**CITY OF RIPLEY
JACKSON COUNTY, WEST VIRGINIA**

**PHASE II – PROPOSED SANITARY SEWER SYSTEM IMPROVEMENTS PROJECT
CONTRACT #3 – PROPOSED 1.2 MGD WASTEWATER TREATMENT PLANT**

ADDENDUM #2

MARCH 23, 2022

SHEET No.	
	45

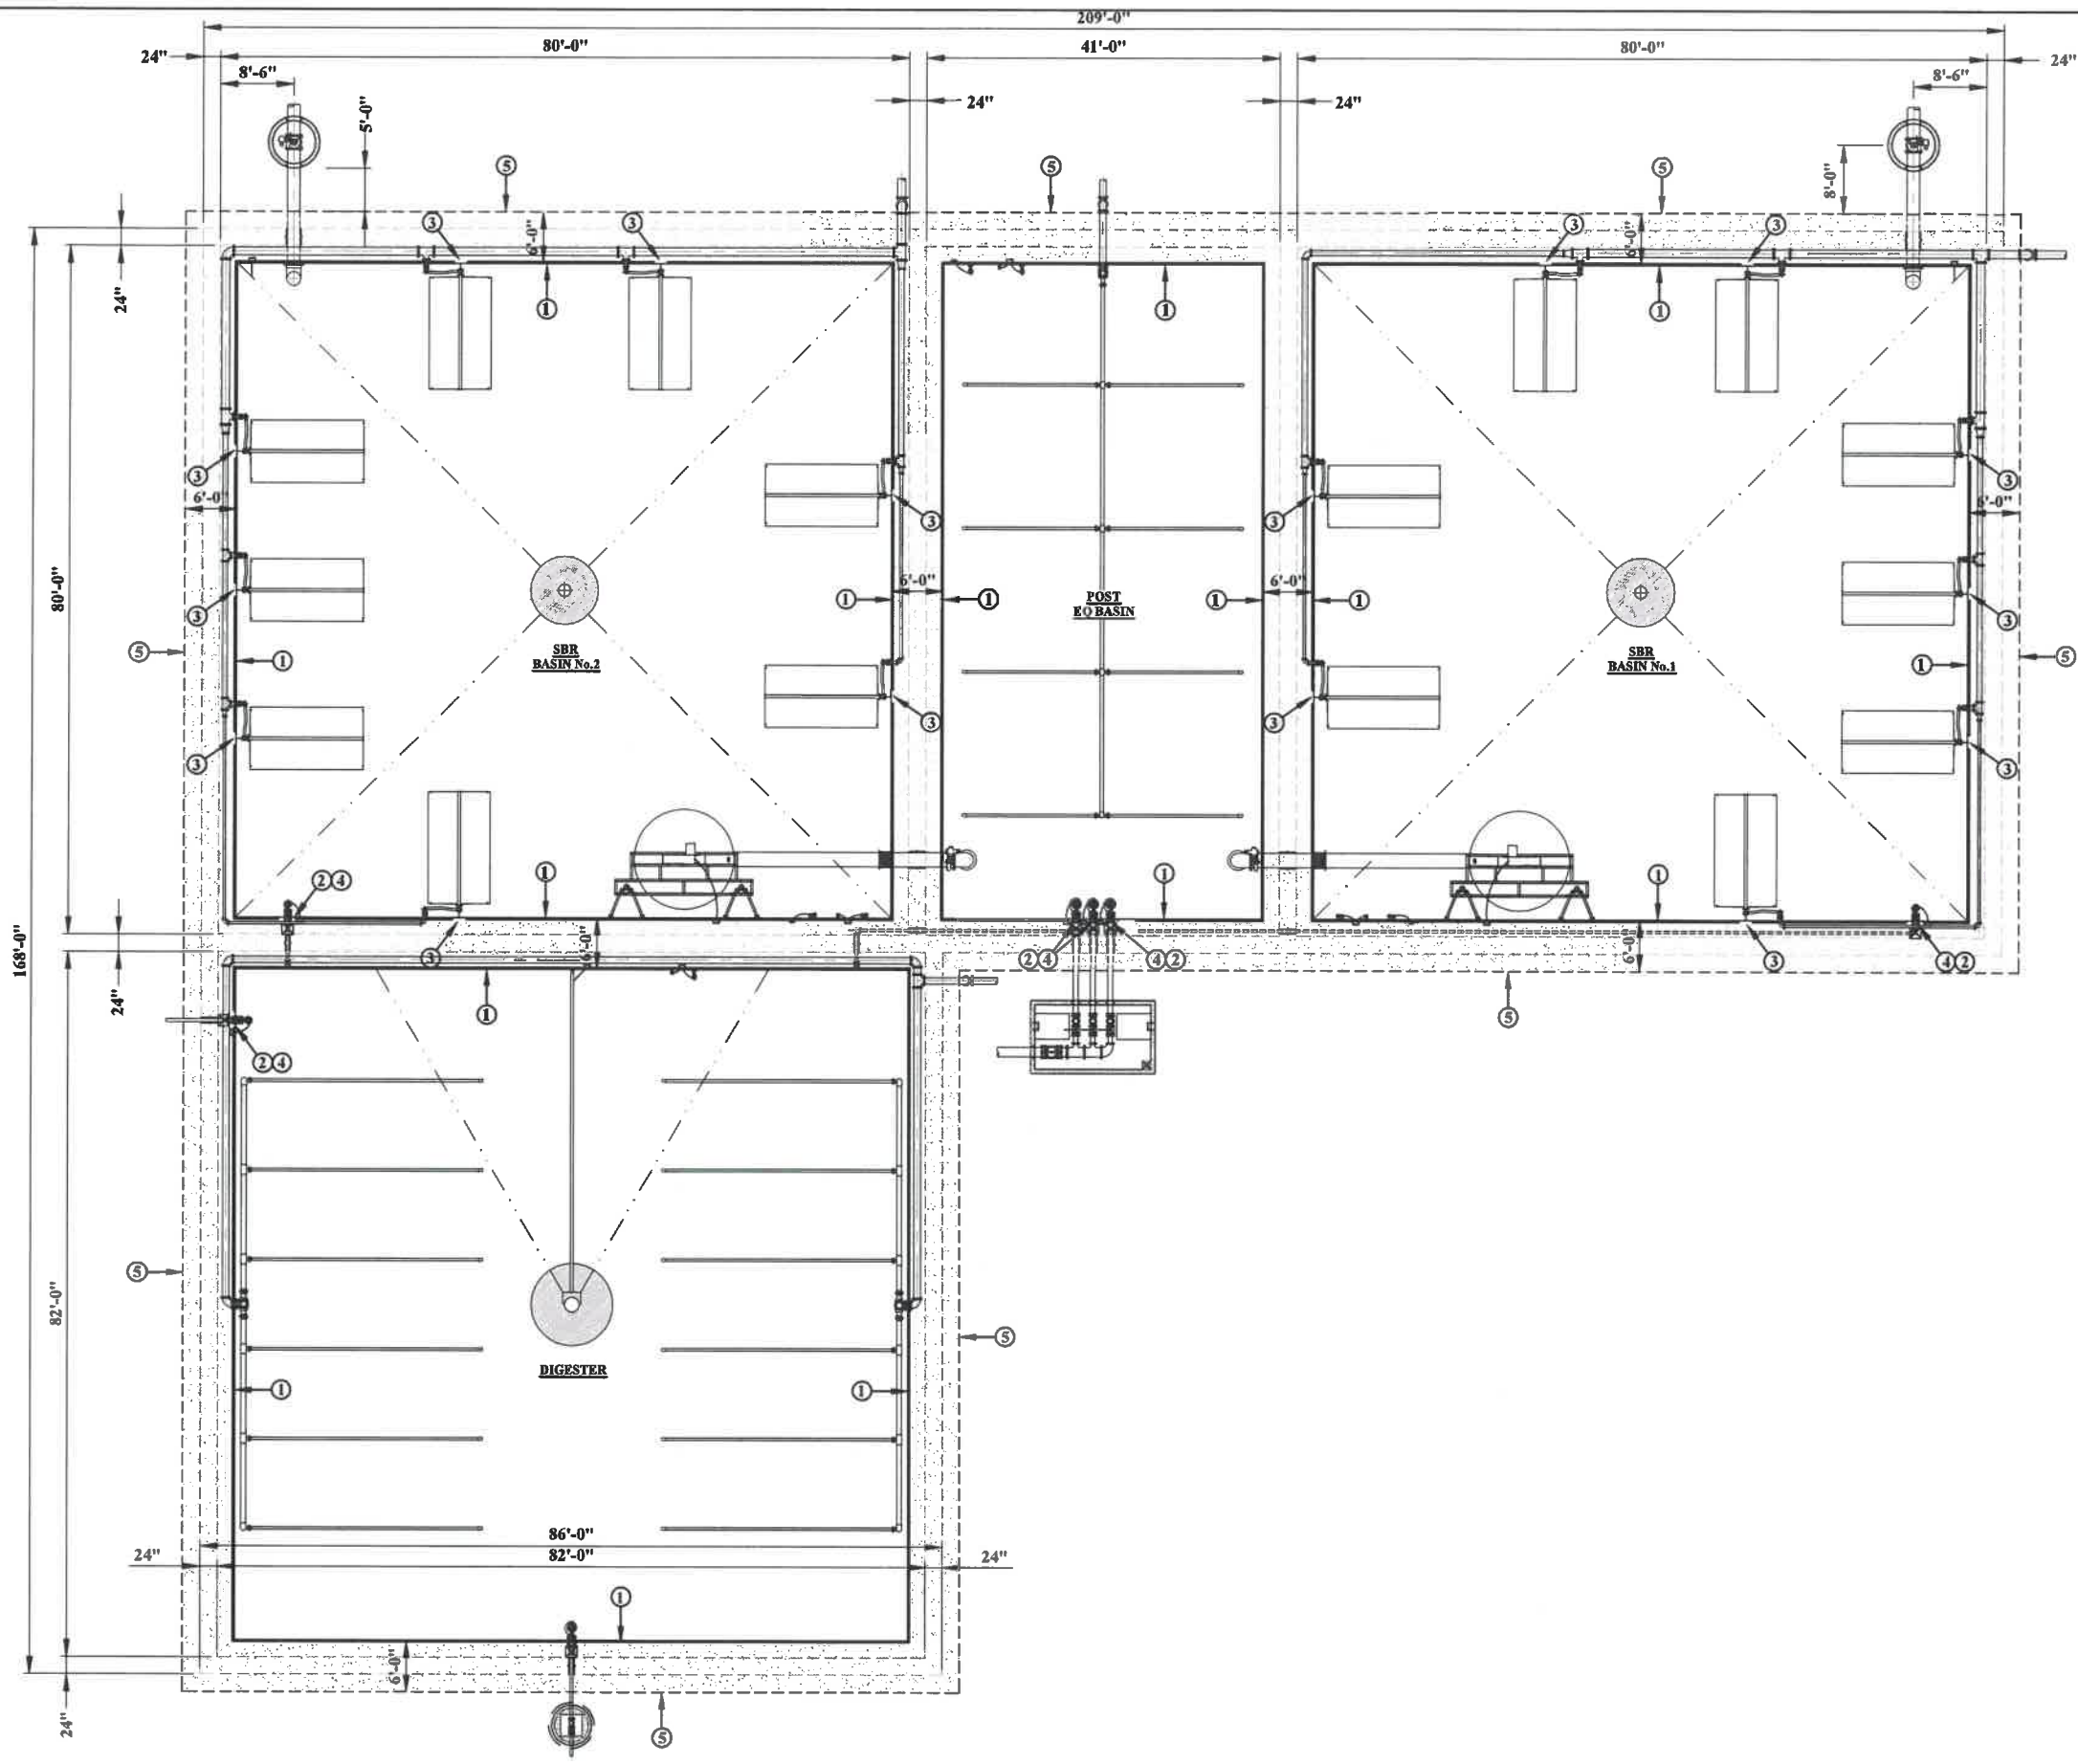
2. Sheet 35
 - a. HWL and LWL locations within the Post-EQ basin have been revised to match the scale.
3. Sheet 45
 - a. Notes added to clarify the supernatant pump and sludge feed pump will be supplied by the Contractor, as detailed in Specification 333220.

SHEET No.
49

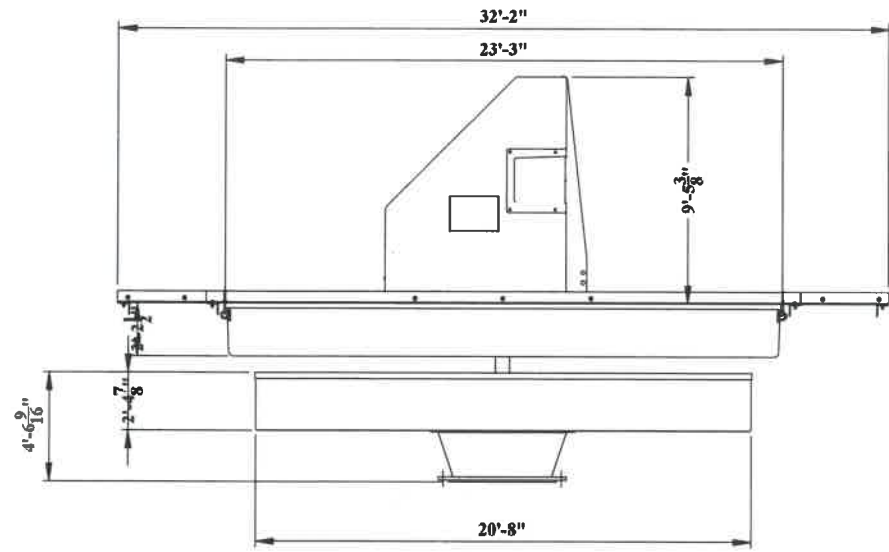
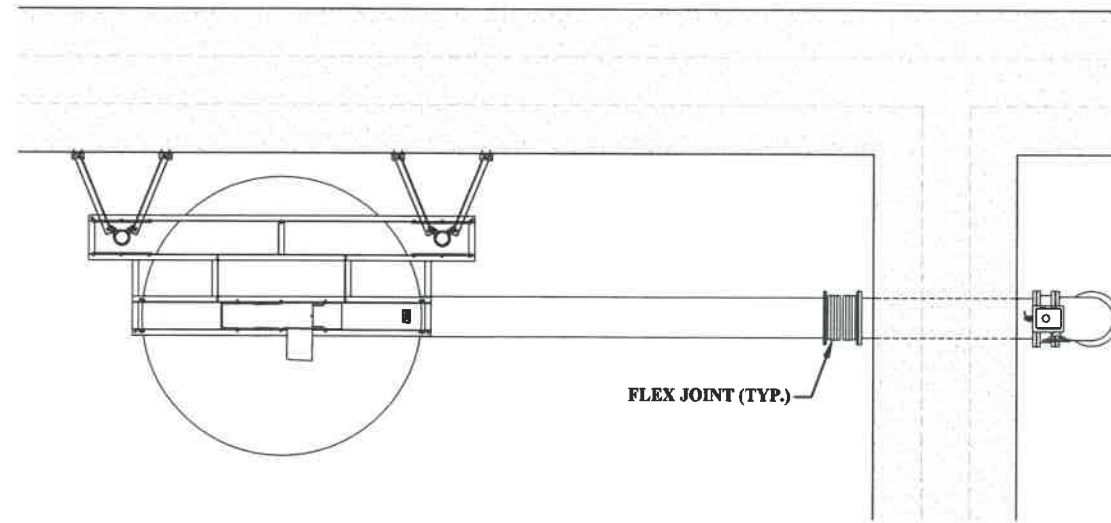
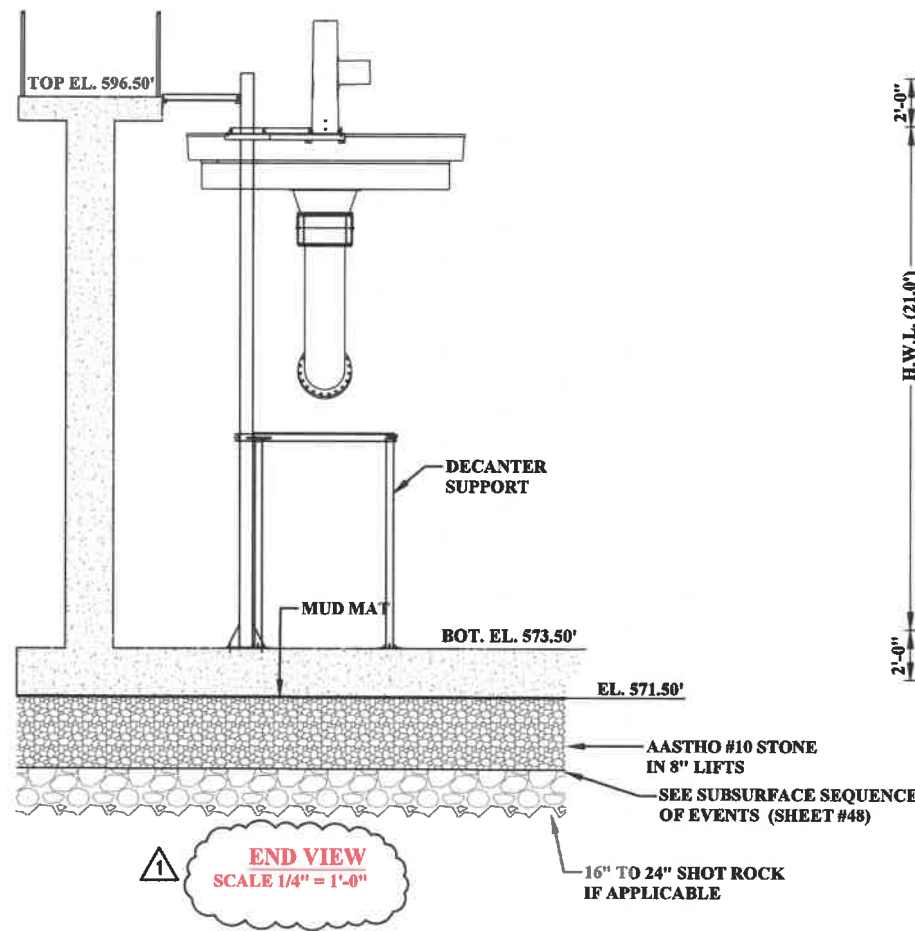
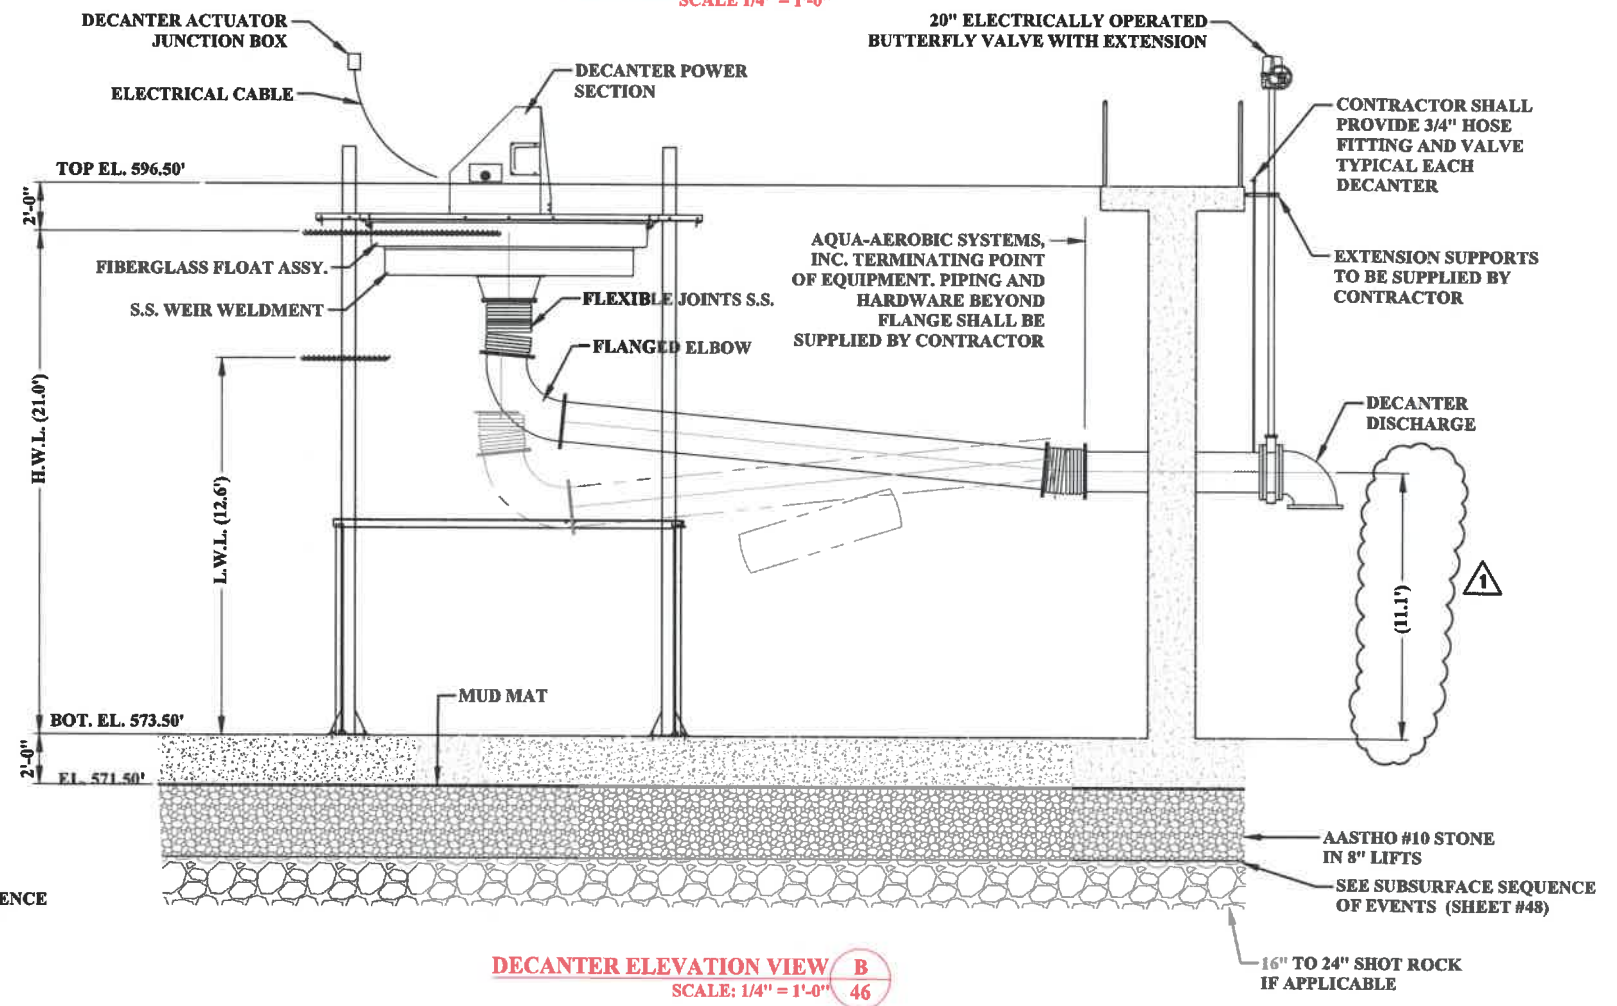
4. Sheet 49
 - a. Centerline of decant pipe adjusted to 11.1’ to reflect Specification 461405.
5. Sheet 51
 - a. Post-EQ water levels have been corrected.
